DEPARTMENT OF THE AIR FORCE  
 1155 TECHNICAL OPERATIONS SQUADRON (AFTAC)  
 MCCLELLAN AIR FORCE BASE, CALIFORNIA 95652

REPLY TO: MCLR (Capt DerBleyker, 643-5313)  
 ATTN OF: MCLR (Capt DerBleyker, 643-5313)  
 SUBJECT: NRC Inspection - License No. 04-09951-03

1. I am providing you a response to your 1 October 1981 letter, Subj: NRC Inspection. Listed below are corrective steps taken for the violations identified in your letter.

RTG Storage Facility

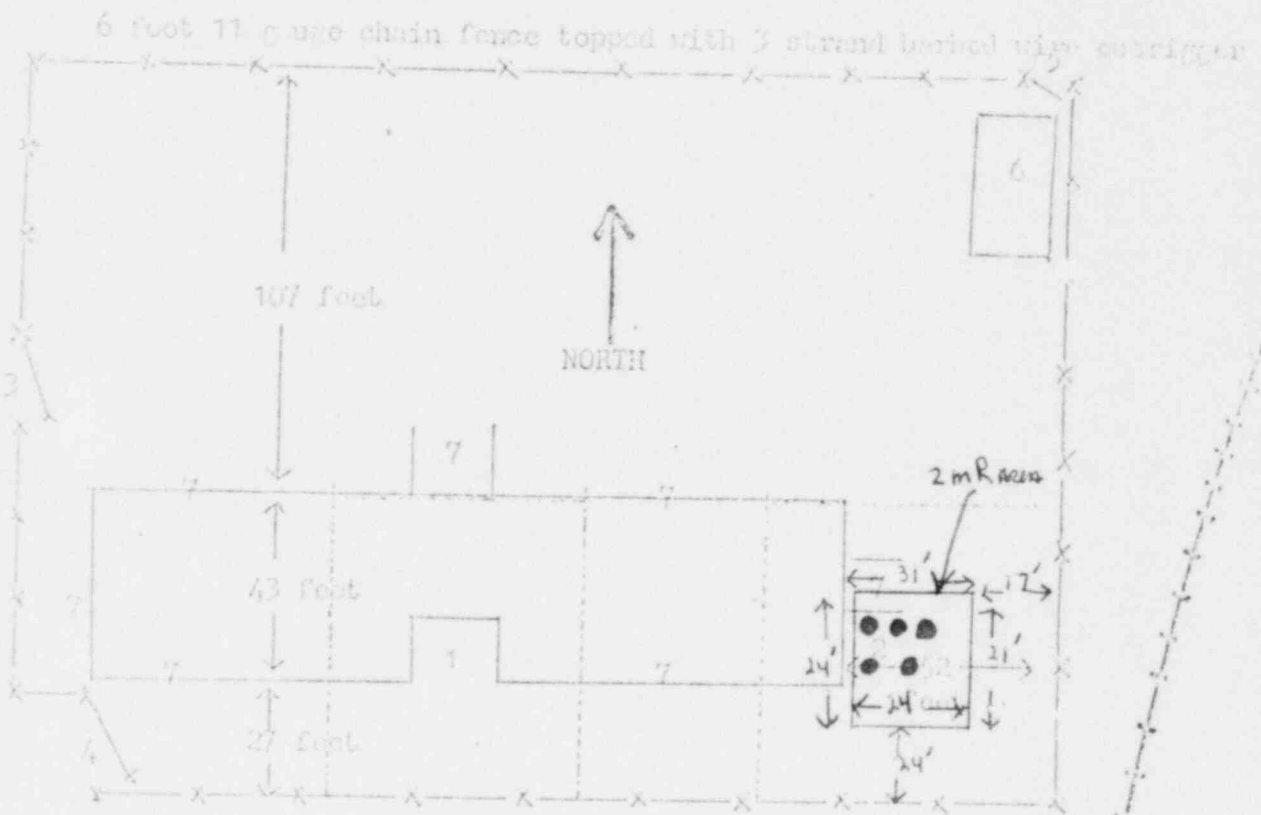
b. Mr. Skov also mentioned that the survey should have included a sketch of the area of the RTG placement. This was accomplished.

c. Copies of the corrected survey of leak tests and a sketch of the RTG storage area are attached.
